**PLANNING APPROVAL,
PLANNED UNIT DEVELOPMENT &
SUBDIVISION STAFF REPORT****Date: November 17, 2011**

<u>NAME</u>	New Hope Baptist Church
<u>SUBDIVISION NAME</u>	New Hope Baptist Church Subdivision
<u>LOCATION</u>	1270 & 1272 Pecan Street, 605 & 608 Live Oak Street, 1261 & 1263 Persimmon Street (Northeast corner of Pecan Street and Live Oak Street extending to the Southeast corner of Pecan Street and Persimmon Street; and West side of Live Oak Street, 120'± South of Persimmon Street)
<u>CITY COUNCIL DISTRICT</u>	District 2
<u>PRESENT ZONING</u>	R-2, Two-Family Residential District
<u>AREA OF PROPERTY</u>	1 lot / 3.4± acres
<u>CONTEMPLATED USE</u>	Planning Approval to allow the expansion of a church and construction of off-site parking for church use in an R-2, Two-Family Residential District; Planned Unit Development approval to allow reduced front yard setbacks and side-street side yard setbacks and off-site parking; and Subdivision approval to create two legal lots of record.
<u>TIME SCHEDULE FOR DEVELOPMENT</u>	Immediate.

SITE PLAN

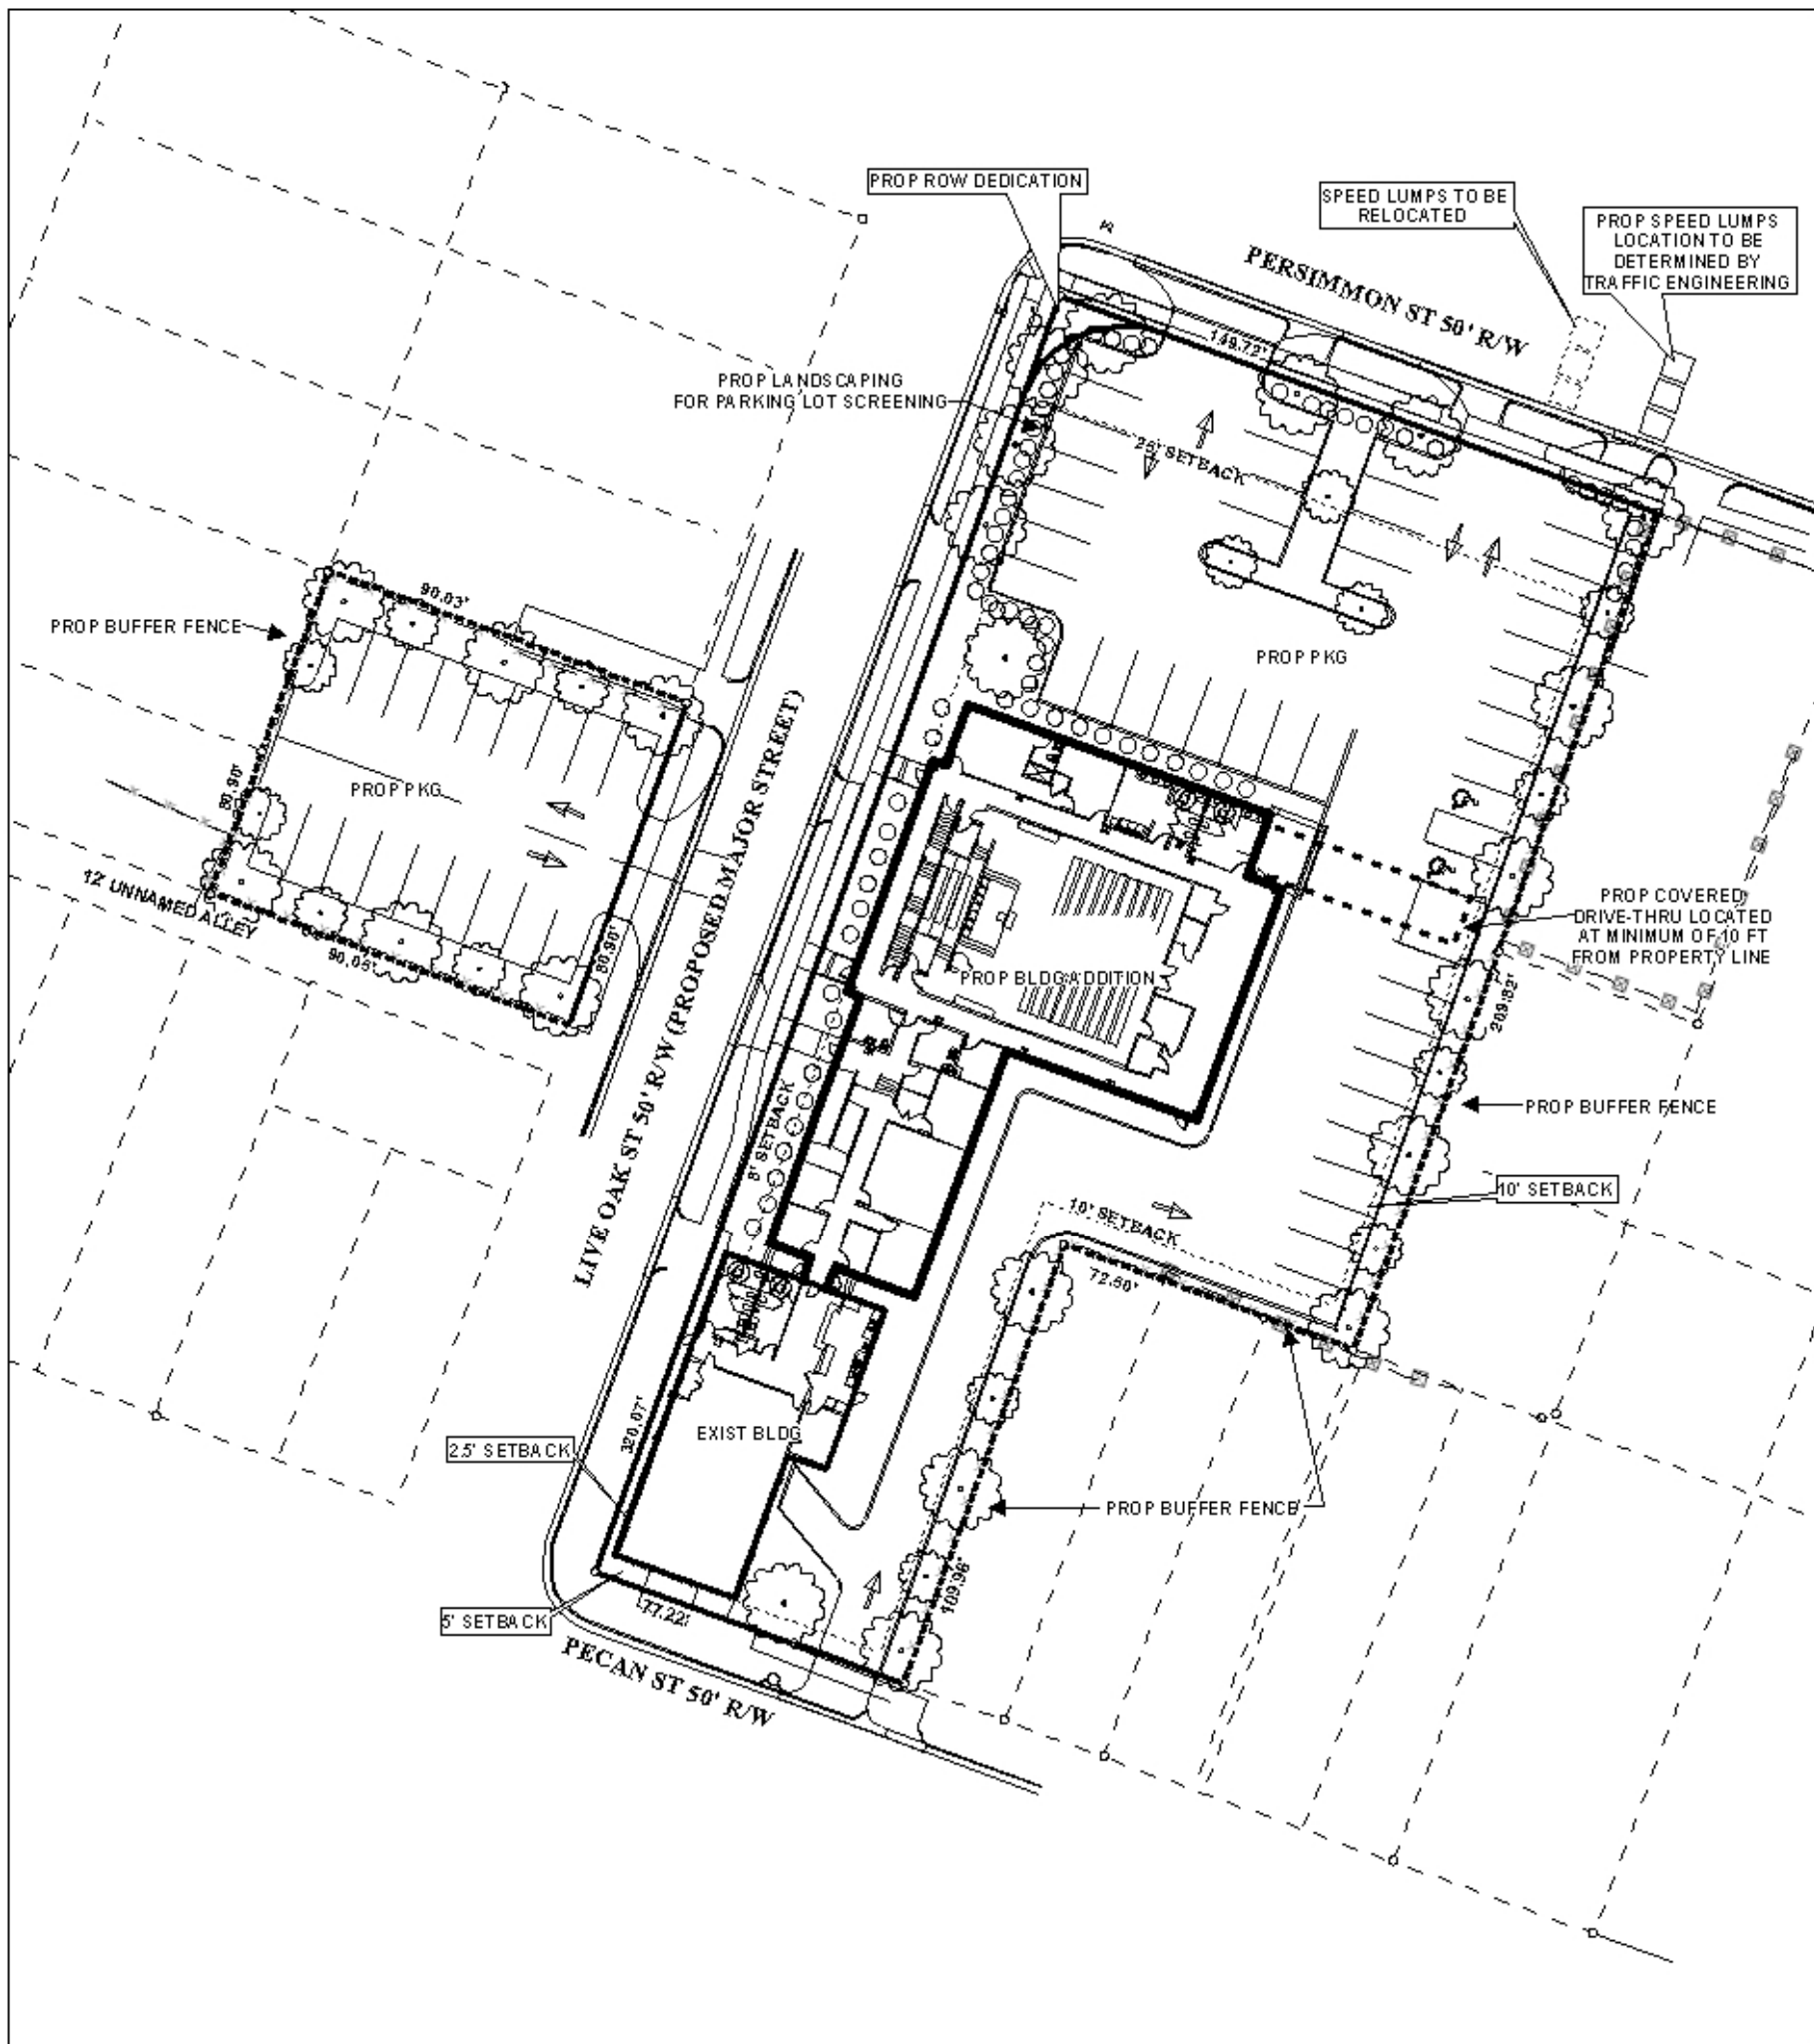
Driveway number, size, location, and design to be approved by Traffic Engineering and conform to AASHTO standards. Driveway access to Persimmon Street should be limited to one driveway, centrally located to avoid conflict with the adjacent speed bumps in the roadway. The proposed driveway on Pecan Street should be narrowed to 14'-16' for one-way traffic. There is no other indication that the aisle is one-way northbound, other than the arrow at the driveway. Aisle should be designated as one-way and wrong way vehicles should be deterred from entering, using angled parking for example. Traffic Engineering is concerned with the line of sight through the double 90° turns within the site. The building and privacy fence obstruct the view of oncoming traffic and parking vehicles through the curves. Traffic Engineering is also concerned with the location of the dumpsters and how they will be accessed. Parking stall widths should be 9' minimum for both lots. The 5' offset within the aisle in the northeast corner of Lot 1 should be eliminated, as it reduces the effective aisle width to approximately 20' for two-way traffic.

Traffic Engineering met with the engineer for the development on Nov. 21st to further discuss the site plan for New Hope Baptist Church. As discussed, the two driveways on Persimmon Street will be acceptable, with the additional detail in the plan to relocate the speed bumps to a location to be determined by Traffic Engineering. We discussed the driveway and aisle, to be redesigned to a width 14'-16'. Additional plan sheets were viewed that indicated wrong way signage at the north end of the aisle, and additional pavement markings were discussed and have been included in the revised site plan. The dumpster pad has been removed from the revised site plan, and per our discussion, the garbage pick-up will be curbside, therefore there is no longer an issue with garbage truck access. The parking stalls have been widened to the minimum 9' width on both lots. The new site plan also corrects the offset parking in the northeast corner of Lot 1.

The proposed layout of the site and improvements presents a problem. The applicant is proposing that the addition have a building setback of 8.5 feet along Live Oak Street. Ordinarily, a 20-foot side-street side yard setback would be required. In this case, however, Live Oak Street, as previously mentioned, is a proposed major street, which requires a 100-foot right-of-way. The existing right-of-way is only 50 feet, therefore, at a minimum, 25 feet should be preserved with a

building setback line to prevent any new buildings or additions from being constructed in the future widening area. As such, the reduced side-street side yard should be denied.

The applicant has proposed an 8-foot side yard setback along the eastern side of the site. A proposed "covered drive thru" is shown on the site plan. The drive thru is depicted as being within two feet of the side property line. The Zoning Ordinance, as per Section 64-4.D.1. requires, in addition to a buffer fence, a 10-foot restricted use buffer between the site and residentially utilized properties. While parking may be placed within the buffer, structures may not be. Additionally, the covered drive thru takes up accessible parking space area, and may not be compliance with the Americans with Disabilities Act (ADA). Further regarding the restricted use buffer area, the dumpster, as shown, is located within the buffer. Due to the layout of the site, and the absolute bare minimum amount of parking provided, the dumpster cannot be moved without causing the site to be deficient on parking.

There are also other issues with the site plan, as presented. The layout does not allow adequate space for frontage trees to be planted along Pecan Street and a sizable portion of Live Oak Street. Tree Plantings are required due to the addition being more than 50% or greater in floor area. Further, the two angled parking spaces nearest to Pecan Street on the south end of the site do not appear to allow adequate maneuvering space without having vehicles to back-out into the right-of-way. Also, a covered porch is shown within the right-of-way of Pecan Street, which would not be allowed to remain.

The site plan also does not depict parking lot screening as required by Section 64-4.A.3.i. of the Zoning Ordinance. This screening would be required along Persimmon Street and Live Oak Street due to residential properties across the street. Additionally, the site would need to comply with Sections 64-4.A.2. and 64-6.A.3.c. of the Zoning Ordinance regarding illumination of uses and arrangement of lights so as not to shine directly into traffic or residential properties. Additionally, the off-site parking lot on the proposed Lot 2 does not indicate proper buffering as required by Section 64-4.D.1. of the Zoning Ordinance.

The site plan, however, still indicates the proposed 8-foot building setback along Live Oak Street. As mentioned previously, Live Oak Street is proposed major street (Cross-Town Loop 2) as shown on the Major Street Plan Component of the Comprehensive Plan. Live Oak Street is depicted with an existing 50-foot right-of-way, however, the Major Street Plan and Section V.B.14. of the Subdivision Regulations require a 100-foot right-of-way.

Again, the proposed layout of the site and improvements presents a problem. Ordinarily, a 20-foot side-street side yard setback would be required. In this case, however, Live Oak Street, as previously mentioned, is a proposed major street, which requires a 100-foot right-of-way. The existing right-of-way is only 50 feet, therefore, at a minimum, 25 feet should be preserved with a building setback line to prevent any new buildings or additions from being constructed in the future widening area. As such, the reduced side-street side yard should be denied.

The site plan also continues to indicate a covered porch within the right-of-way. The covered porch should be removed from the right-of-way.

The site plan now contains a note stating that the site will be serviced via curbside garbage pickup, and the dumpster has been removed. The covered drive-thru has also been modified to meet building setbacks. Additionally, the driveway alignments have been modified to meet Traffic Engineering requirements, and they have also allowed for more landscaping area to be provided.
